Access Compliance Report Public Rights-of-Way (Curb Ramps)

Main Street: BASKERVILLE_RD		Cross Street: DRYSDALE_LN		Location:	SE
ADA ID: RPRK211215122520		Ramp Type:Type 1 - Perpendicular Diagonal Initial Pass/Fail: Pass		Overall Compliance: No	Severity Score: 10
Codes/Mitigation Info/Possible Solution			Field Measurements/Component Compliance

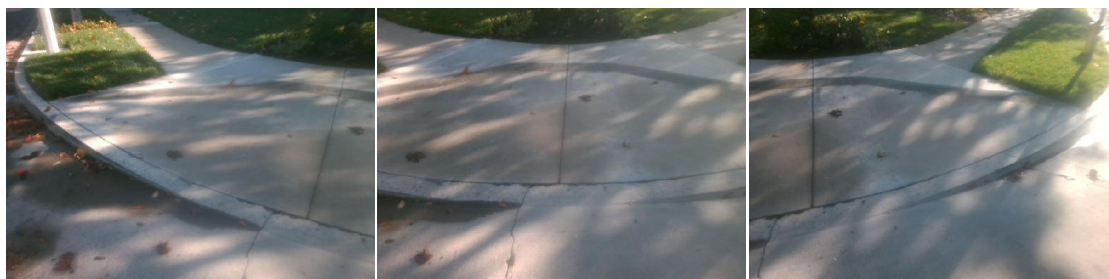
R204.3, R305, STD 1115

Remove & Replace Curb Ramp With Two New Directional Ramps or Equivalent.
